Re: A request by Gary Ramm and Kevin Harms for Preliminary Plat approval of Leaf Lake Estates 2nd Addition, a proposed three (3) lot subdivision. The property is located in part of the NE $\frac{1}{4}$ SE $\frac{1}{4}$ of Section 10, Buffalo Township, the property is zoned Single Family Residential (R-1).

PRELIMINARY PLAT OF:
LEAF LAKE ESTATES 2ND ADDITION
 BEING A REPLAT OF LOT 23 IN LEAF LAKE ESTATES IN THE NORTHEAST QUARTER OF
 THE SOUTHWEST QUARTER OF SECTION 10, TOWNSHIP 71 NORTH, RANGE 2 EAST OF
 THE 5TH PRINCIPAL MERIDIAN, SCOTT COUNTY, IOWA.

PLANNING & ZONING COMMISSION
STAFF REPORT
February 17, 2009

Request: Preliminary Plat of Leaf Lake Estates 2nd Addition, a proposed three (3) lot residential subdivision..

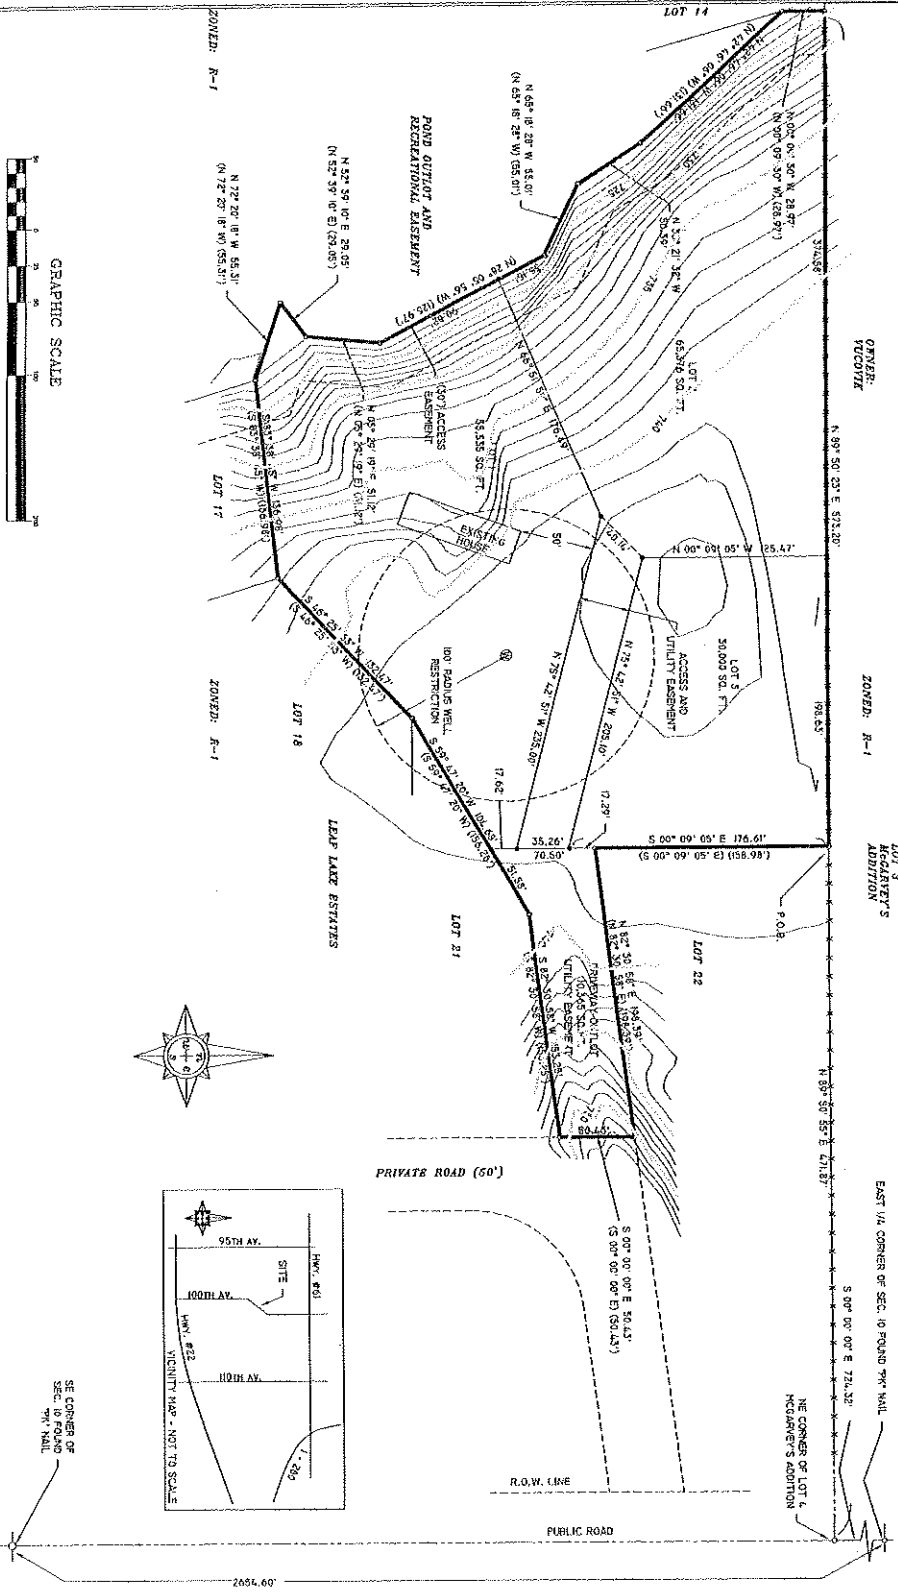
STAFF REVIEW: Staff has reviewed this request for compliance with the requirements of the Subdivision Regulations and the Zoning Ordinance. The proposed lots meet the minimum lot size required by Health Department Regulations and the R-1 zoning district requirements. As stated above, one of the development lots is at the minimum lot size of .69 acres; the second development lot is 1.5 acres in size and the existing house would be on the 1.3 acre balance with .25 acres of the property included in the shared access and utility easement.

As stated above, access to these two new lots will be from a shared driveway located in an access and utility easement located in the location of the existing driveway to the property that intersects with Leaf Lake subdivision's private road. Because these properties only access to the public County road, 100th Avenue, is by the Leaf Lake private road, 123rd Street, staff would recommend that these lots be required to participate in the upkeep and maintenance of that road. However, the subdivision regulations do

allow subdivision roads, such as the proposed shared driveway, which will not serve more than four lots to be constructed with a 6 inch road base and two inch chip seal surface 20 feet in width with two foot shoulders adjacent to the roadway. Staff has recommended that provision for a turnaround be provided at the end of the common road easement serving these three lots.

The Subdivision regulations require the internal street to be adequately drained and that detention facilities, adequate to capture the runoff from a one hundred (100) year rain event, calculated at post-developed flows, must be shown on the subdivision plans. The release rate from that detention area shall not exceed the volume produced by a five (5) year event, calculated at pre-developed flows. The stormwater drainage plan and the design of detention facilities are required prior to Preliminary Plat approval. Because of the relatively minor nature of this subdivision staff would recommend that a stormwater drainage plan be submitted and reviewed with the road construction plans.

The subdivision regulations also require the submission of an erosion and sediment control plan prior to Preliminary Plat approval. Again staff would recommend that those plans be submitted and reviewed with the road construction plans. The plans shall include information regarding the soil types, the specifications for temporary and permanent erosion and sedimentation control.

The applicant proposes to serve the lots with the existing private well adjacent to the existing house. There is a requirement that no septic system be placed within 100 feet of the well and that 100 foot well easement is shown on the plat.

Zoning regulations do not allow accessory buildings to be placed on residential lots without an existing residence to which it would be accessory. In this case the existing outbuildings are accessory to the existing house but replatting of the property would place them on the adjacent undeveloped lots. The property owner has stated that a condition of the sale of this property is that those buildings will have to removed within six months of the sale. The zoning regulations would require removal of those buildings prior to Final Plat approval which would necessitate their removal before the sale of the property. The Planning Commission could recommend approval of the final plat without the buildings being removed if an adequate legal mechanism or surety was in place to make certain they were removed within a definite timeframe.

1. The City of Buffalo also review and approve the Preliminary and Final Plat prior to Final Plat approval by the Board of Supervisors;
2. The private covenants include provision for equitable participation of these properties in the road and common open space maintenance of Leaf Lake Estates;
3. The County Engineer review and approve all drainage, erosion control and street construction plans prior to construction;
4. The subdivision infrastructure improvements be completed or a surety bond posted prior to Final Plat approval: and
5. The accessory building on proposed Lot 2 and 3 be removed prior to Final Plat approval.
